## **EASA Position regarding FAA AD 2023-11-07 – Not eligible for adoption**

[Docket No. FAA-2023-0668; Project Identifier AD-2023-00199-R; Amendment 39-22453; AD 2023-11-07]

### Airworthiness Directives; Various Helicopters

Figure 1 to paragraph (g)(1)(i)— *Fundamental Effective Isotropic PSD at Outside Interface of Rotorcraft Antenna*

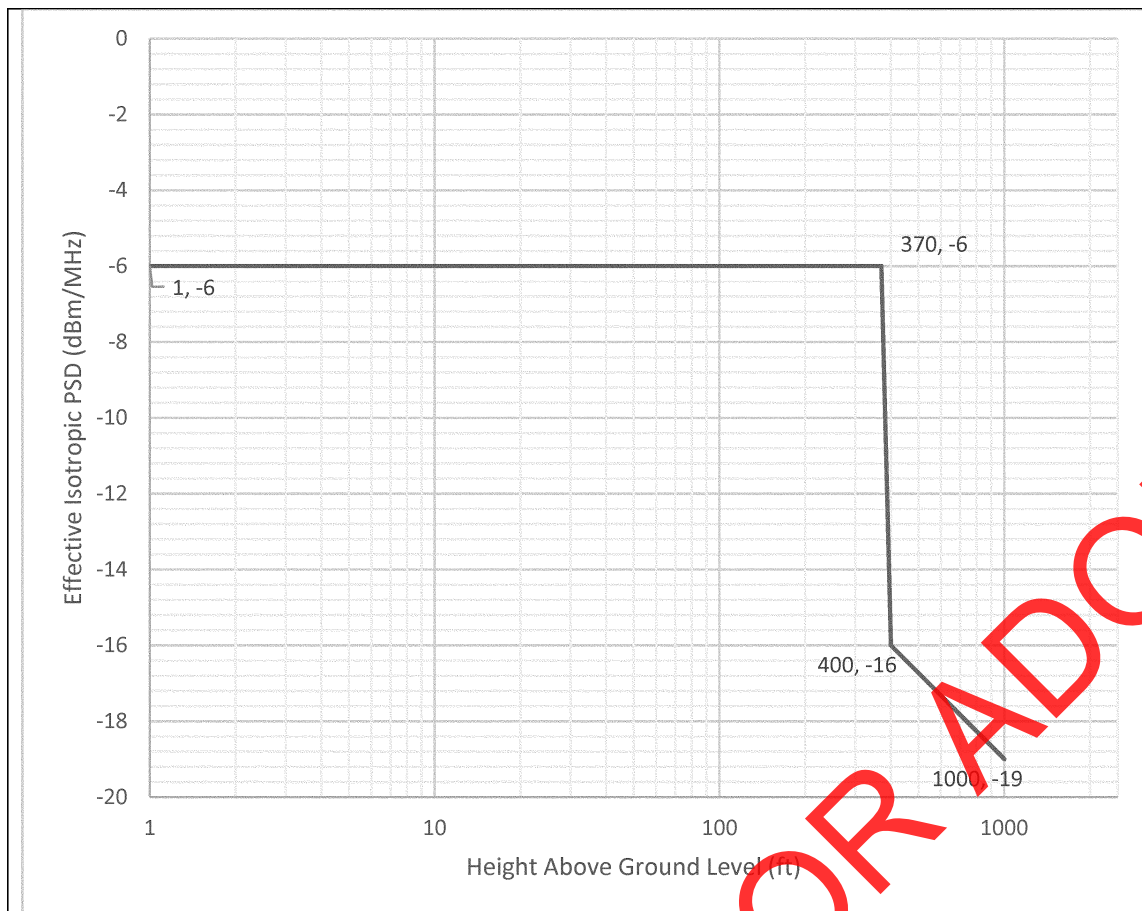
*Comment summary:* Thales and Sikorsky requested the FAA clarify several aspects of the PSD curve in figure 1 to paragraph (g)(1) of the proposed AD: whether no elevation mask is taken into account at and below 350 feet above ground level (AGL); at which base station emission power the PSD curve corresponds (62 dBm/MHz or 65 dBm/MHz); and whether the radio altimeter performance criteria in the curve explicitly covers any 5G emitter station up to 65dBm/MHz in the applicable 3.7–3.98 GHz band, for the foreseeable future. Sikorsky requested that the FAA revise the proposed AD to include a PSD curve that reflects the reduced EIRP levels for helicopters operating at the 188 priority airports (5G CMAs) with reduced power levels.

*Comment summary:* Sikorsky requested the FAA revise the PSD curve in figure 1 to paragraph (g)(1) of the proposed AD to change the height above ground at  $-6$  dBm/MHz from 270 feet to 370 feet, and at  $-16$  dBm/MHz from 300 feet to 400 feet. Sikorsky stated its request was based on several factors, including the minimum safe obstacle avoidance distance and the typical decision height used for radio altimeter critical operations associated with missed approach points (MAPs) during point in space (PINS) approaches. Sikorsky further stated that radio altimeters are not operationally used above 1000 feet, and therefore there is little value for any PSD restrictions above 1000 feet operationally.

*FAA response:* The notch in the PSD curve does not mean that no elevation mask is taken into account below 350 feet AGL. The elevation mask is taken into consideration below 350 feet AGL and is a fundamental consideration in how the PSD curve was established. The PSD curve was calibrated to cover 5G C-Band emitter stations up to 65 dBm/MHz in the applicable 3.7–3.98 GHz band.

*FAA response:* The FAA assumed an emitter base station height of 350 feet based on consensus reached in rotorcraft industry group meetings. Additionally, FAA analysis of existing emitter base station height data shows that, while higher emitters do exist, they are infrequently adjacent to helipads. Second, the FAA assumed the rotorcraft was no closer than 50 feet above and 75 feet laterally from the emitter. The vertical distance was based on pilot feedback and the lateral distance was based on common lateral separation from the main rotor tip recommendations of 2 main rotor diameters from the tip of the rotor, selecting a 30 foot rotor as the smallest rotor in this class of aircraft with the antenna under the main rotor mast. An operator of an individual model rotorcraft with a larger rotor diameter may request approval of an AMOC to the AD on the basis of separation distance. Third, the FAA assumed that the emitter was active at the full rural power level of 65 dBm/MHz allowed in FCC Report and Order FCC 20–22.[2] The FAA then evaluated the resulting curve against data from radio altimeters and found it to be achievable with current technology using filters that have been developed. Based on data from existing emitters, if the height reduction from 370 feet to 270 feet, as requested by the commenter, were adopted, it would result in many more landing scenarios unprotected from

interference because emitters on towers at about 250 feet as opposed to the accepted assumption of 350 feet are much more common. For this reason, the FAA did not adopt this request.

The FAA has re-evaluated the need for PSD performance requirements above 1000 feet and agrees with the reasons provided by the commenter. The PSD curves specified in this AD have been changed accordingly.

Figure 2 to paragraph (g)(1)(ii): *Spurious Effective Isotropic PSD at Outside Interface of Rotorcraft Antenna*

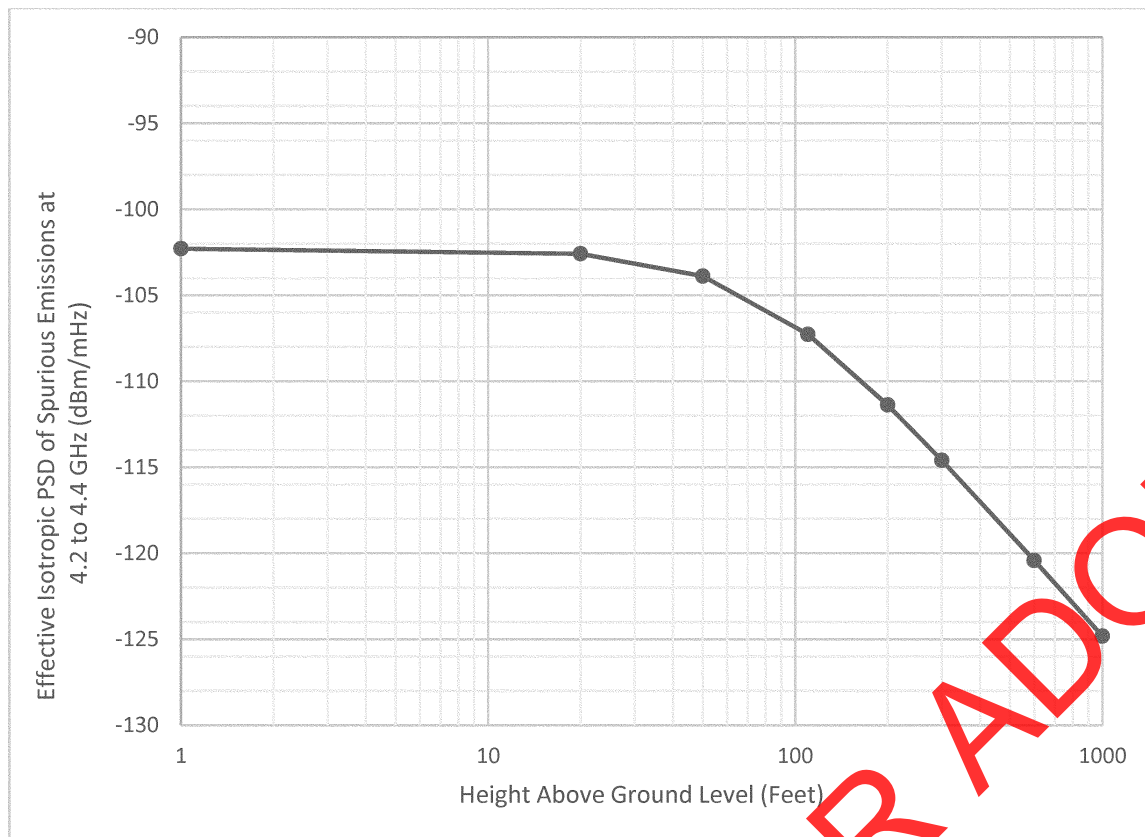
Since the FAA issued the NPRM, the FAA determined that the spurious emission level as proposed in the NPRM would not necessarily address the unsafe condition from both indoor and outdoor emitters. Additionally, commenters of the NPRM requested the FAA replace the proposed fixed aggregate spurious emission level with a spurious PSD tolerance curve.

In this final rule, the FAA replaced the proposed fixed aggregate spurious emission level of  $-42$  dBm/MHz (conducted) with a spurious PSD tolerance curve for 5G C-Band interference from a single base station. This form of the requirement is consistent with the transport and commuter category airplane requirement. Similarly, it does not include an aggregation factor or any base station or aircraft antenna gain factors. The spurious PSD tolerance curve is based on a different spurious emission level than what the FAA proposed in the NPRM ( $-30$  dBm/MHz conducted for a single indoor base station instead of  $-48$  dBm/MHz conducted for a single outdoor base station and an aggregation factor of 6 dB which yielded an effective aggregate level of  $-42$  dBm/MHz).

*Comment summary:* HAI, Sikorsky, and Thales requested that the FAA revise the proposed AD to include the frequency range to which the PSD tolerance curve thresholds apply, a new figure indicating the spurious tolerance similar to the figure with the PSD tolerance curve, and a specification of the altitude dependence for spurious tolerance.

As a result, the FAA is requesting comments on the spurious PSD tolerance curve in figure 2 to paragraph (g)(1)(ii) of this AD.

*FAA response:* The FAA agrees and has added the frequency range to the PSD tolerance curve. Additionally, as explained previously under “Actions since the NPRM Was Issued,” the FAA has replaced the proposed fixed emission level with a spurious PSD tolerance curve.
